SP Transmission & Distribution

Impact Assessment and Consultation on Western Power Distribution's Modification Proposal to change their Electricity Distribution Use of System Charging Model – Ref: WPD/WALES/WEST/UOS002A.

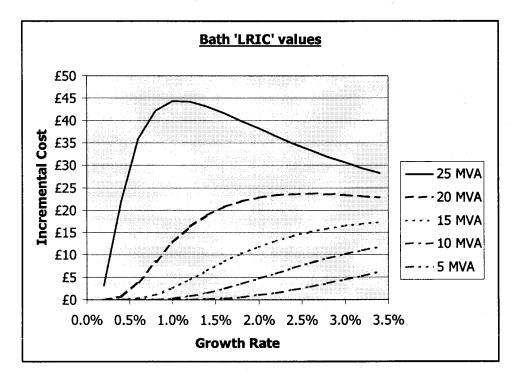
The LRIC method being used by WPD does not, in our opinion, reflect costs. Similar concerns have been raised by a number of parties in the various DNO consultations on the long-term review of structure of charges. As part of Ofgem's consultation on the work undertaken by Bath University, which you refer to in your consultation, we highlighted the key characteristics of the LRIC approach for an asset with a capacity of 30MVA. This is repeated below.

The underlying characteristics of the LRIC approach will result in lower marginal costs where higher growth is forecast: this is counter intuitive and incorrect. In addition if the actual load growth is zero or negative, which is possible if not probable given the recent increases in retail electricity charges and the continued government focus on reducing energy consumption, then there would be no reinforcement requirement.

WPD assume a growth rate of 1% across both WPD licensed areas. The reason for this is that the WPD method only gives reasonable answers using this growth rate assumption: it does not work with low or zero growth and produces reduced marginal costs for higher growth rates, which is incorrect. Our analysis indicates that current growth rates in the WPD areas are actually negative, furthermore the Energy Review says that a fall in energy use relative to GDP at the national level in excess of 1.8% per year is required in order to achieve the Government's energy efficiency goals. We cannot see how the Authority can approve a methodology, which does not cope with a scenario of reducing demand against a context of increasing political and environmental pressure to reduce energy consumption.
